Current Zoning: R-4 (single family residential) and B-1 (neighborhood business)
Proposed Zoning: B-2(CD) (general business, conditional)

Approximately 0.664 acres located on the north side of Joyce Drive, west of Milton Avenue, and south of The Plaza.

The petition proposes to allow additional parking to accommodate an existing auto repair facility.

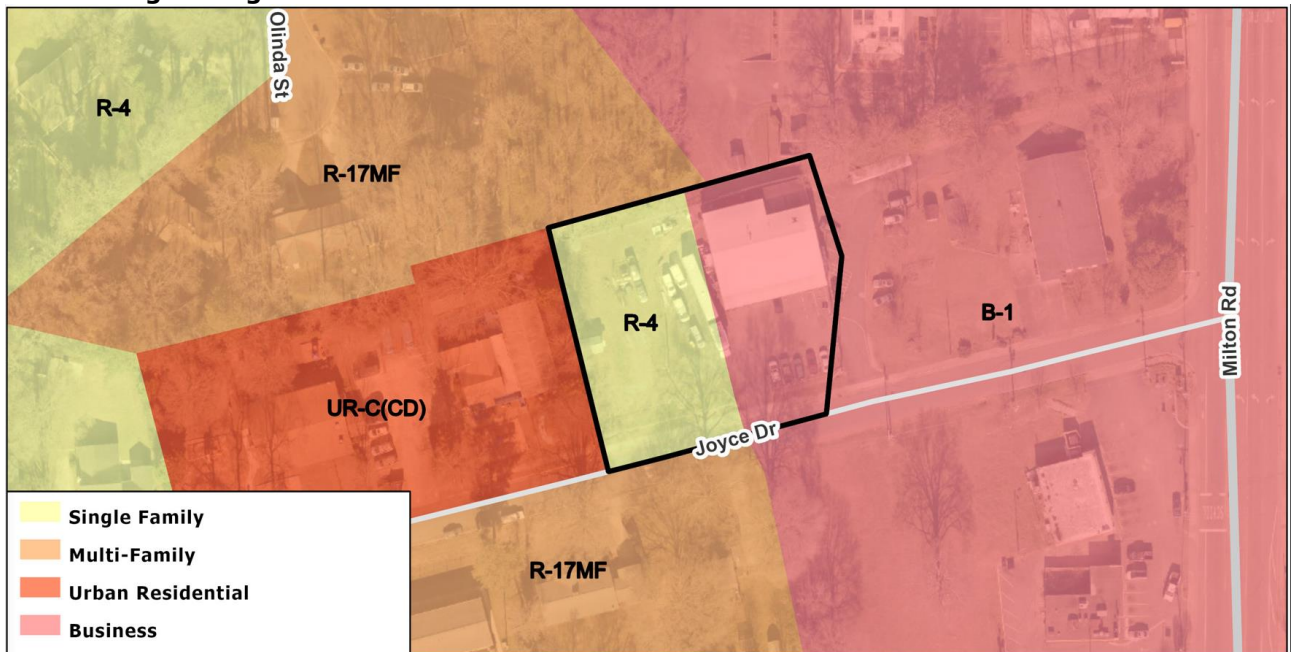
- ~~1. Revise site plan labeling the existing right of way along the site frontage. The site plan shall label and dimension the right of way from the road centerline.~~
- ~~2. Revise site plan and conditional note(s) to commit to construct an 8-foot planting strip, and 5-foot sidewalk on Joyce Drive. The site plan shall label and dimension both items from the back of curb and gutter.~~
- ~~3. Conditional note should state that transportation improvements shall be approved and constructed at the time that the permitted uses for the site changes.~~
- ~~4. Verify streetscape requirements for this Rezoning. If existing sidewalk is to remain in place, call out on site plan and add to conditional notes.~~
- ~~5. Revise conditional note 5.A) by replacing NCDOT with CDOT as Joyce Dr is City maintained.~~

- ~~6. Limit building height to 40 feet.~~ **Addressed**
- ~~7. Clearly label Class B buffer required along portion of north property line abutting existing single-family residence and proposed along the property line abutting the existing daycare facility. Note buffer may be reduced in width by 25% to 20 feet with a wall or fence.~~ **Addressed**
- ~~8. Please confirm streetscape requirements along Joyce Drive frontage, including five-foot sidewalk and eight-foot planting strip.~~ **Rescinded**
